2009 SANITARY SEWER PIPELINE REPLACEMENT PROJECT

PROJECT NO. 09-593-52-211

ADDENDUM NO. 2

June 18, 2010

ADDENDUM No. 2; 'EXHIBIT B'

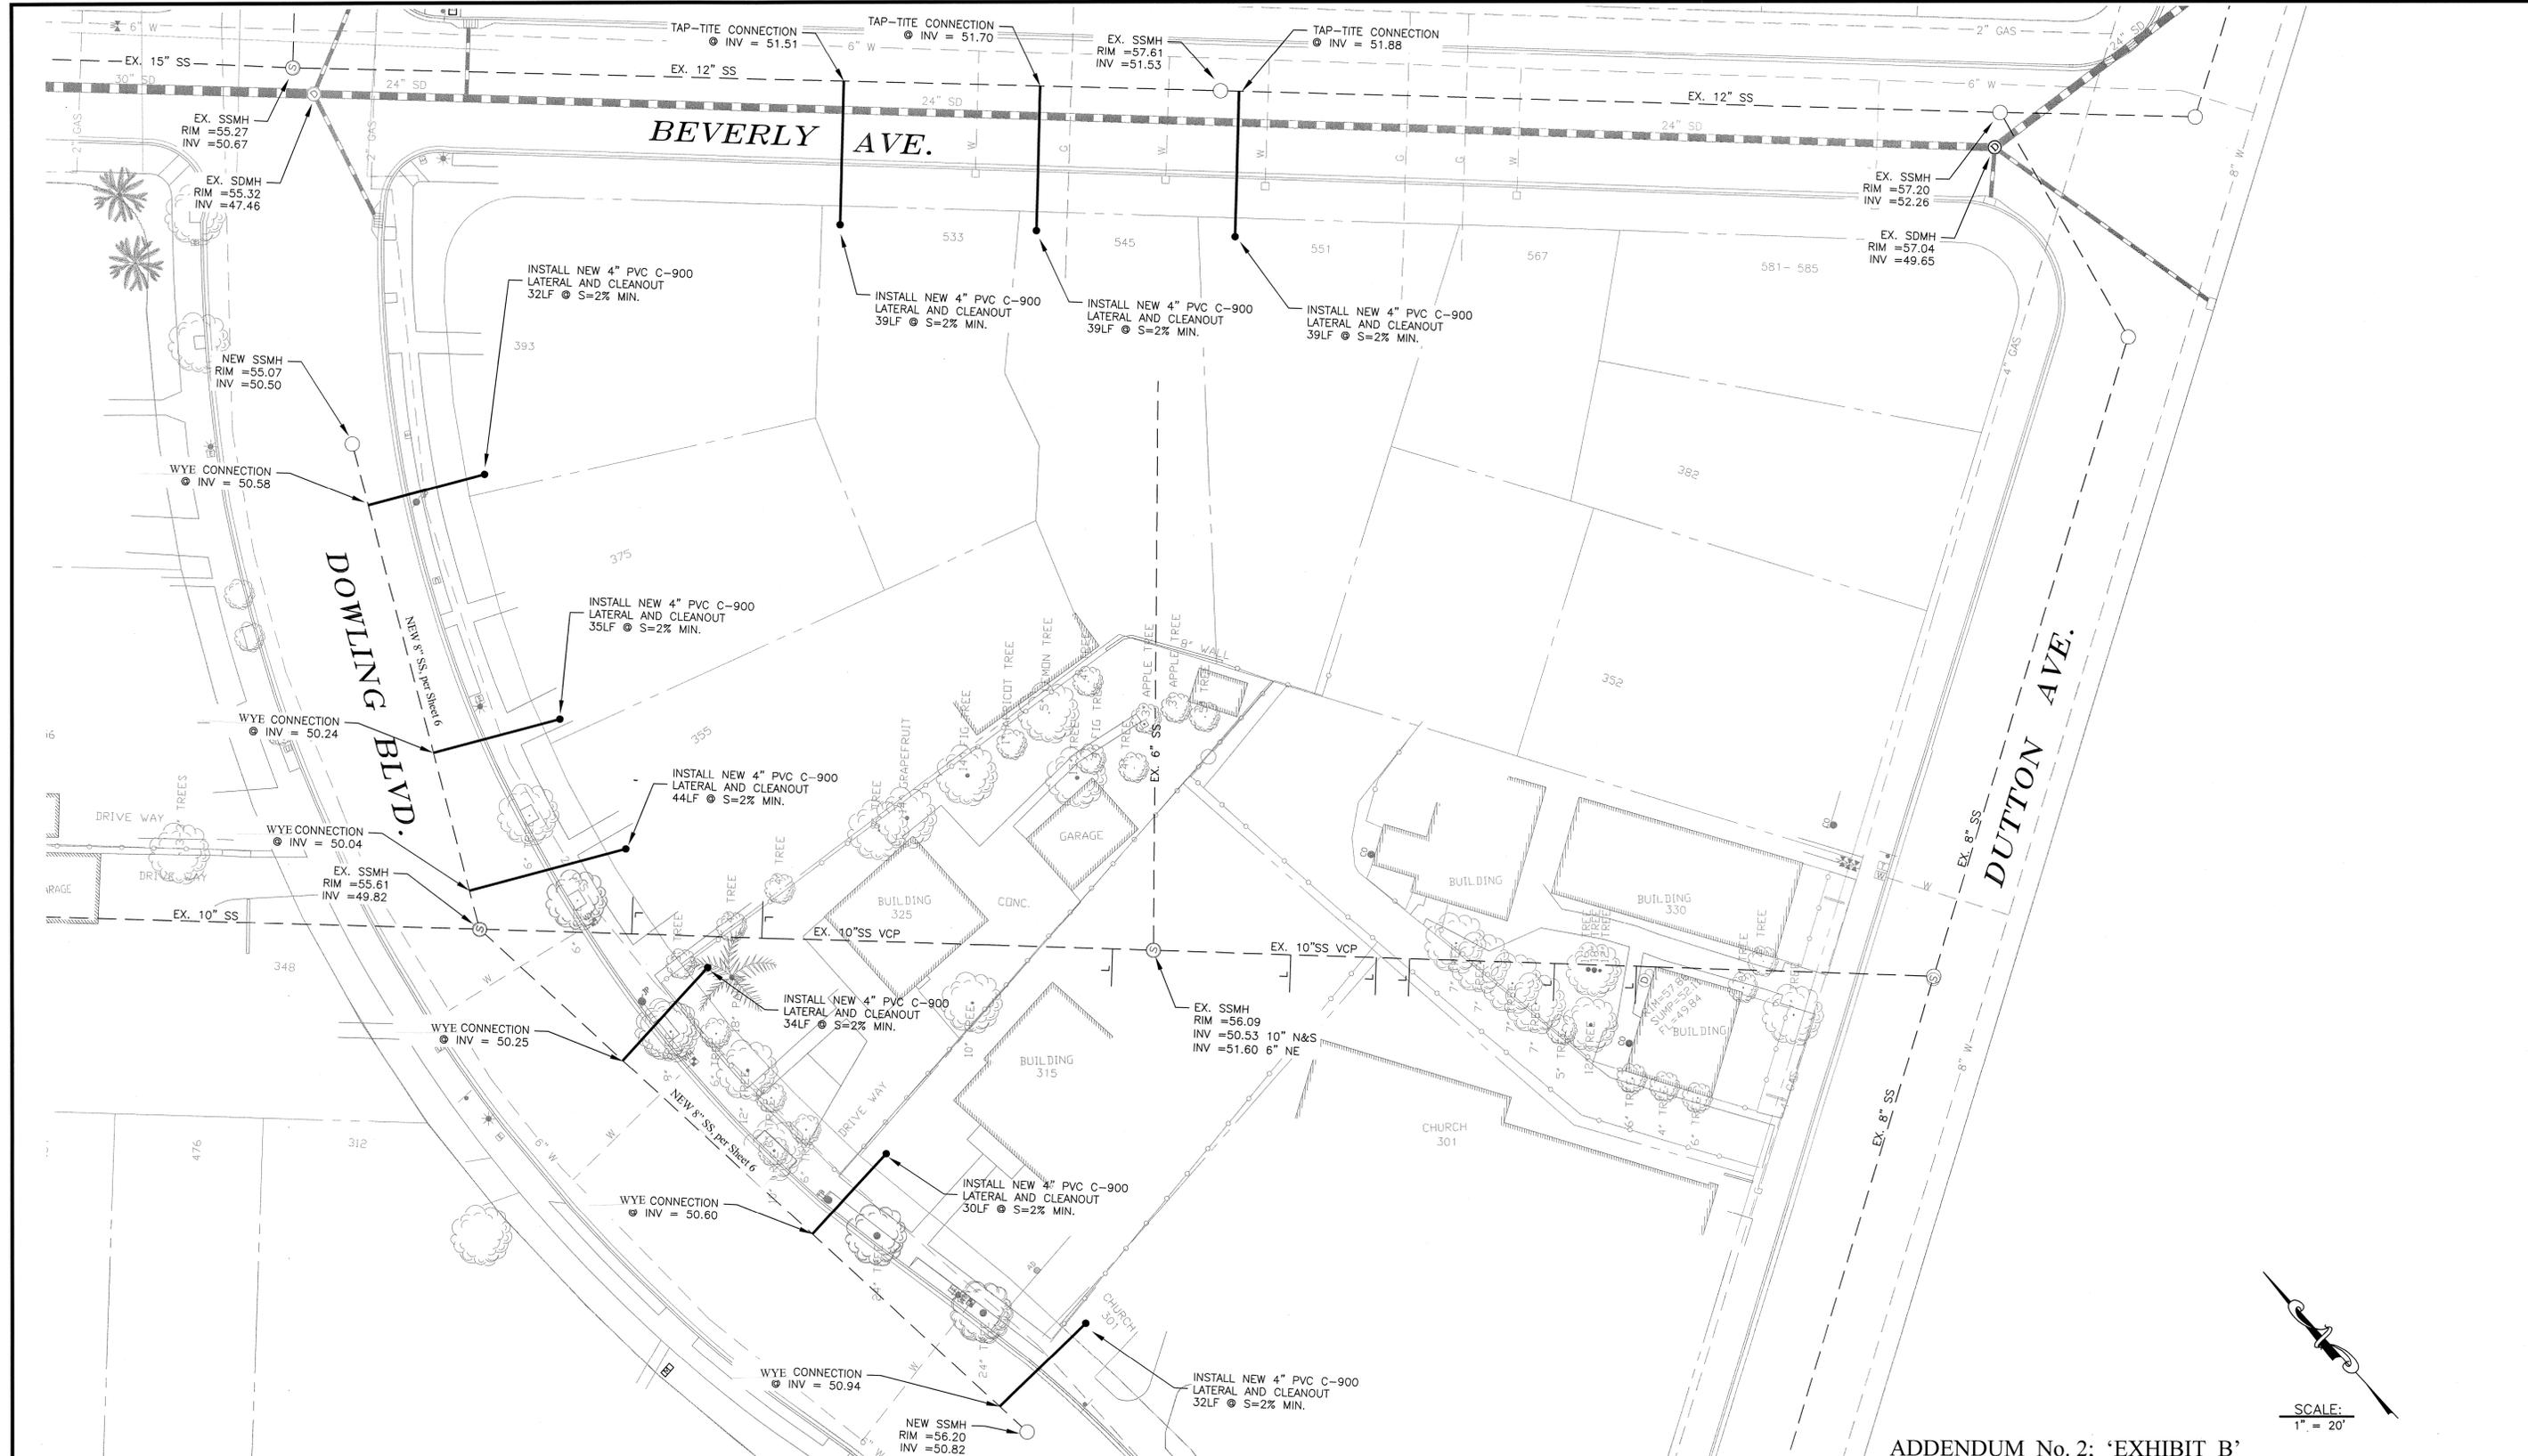
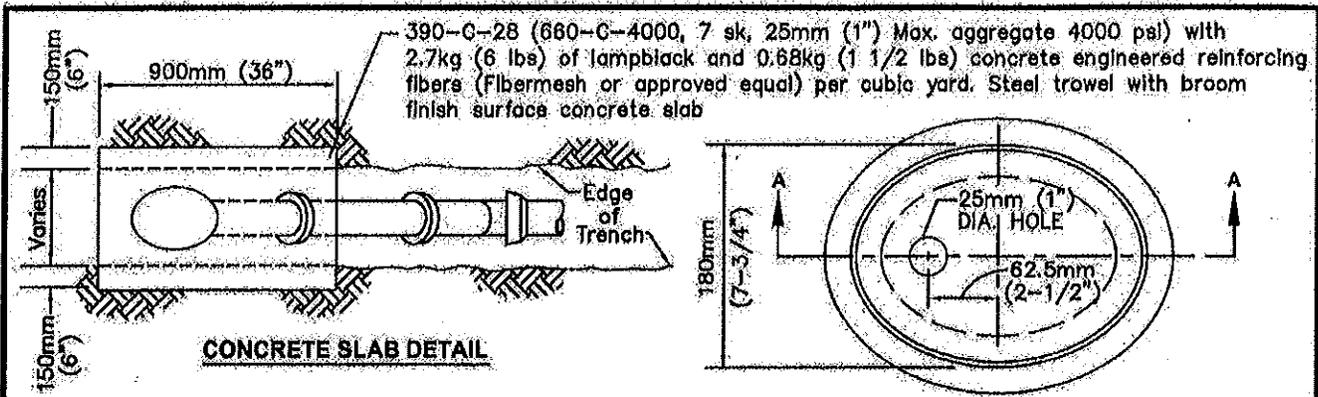
8. Plan sheet 6A, indicating sewer laterals and cleanouts installed in the Right of Way, is added as 'Exhibit B.'
9. City Standard Plan for "Pipeline Riser and Cleanout" (Dwg. 302, Case 3101) is added as 'Exhibit C.'
10. Improvements indicated on plan sheets 7 through 13, shall be bid as "Base Bid" items. Improvements indicated as "Project Site Beverly Ave.," on plans sheets 3, 4, 5, 6 and 6A, shall be bid as "Alternative Additive Bid" items.
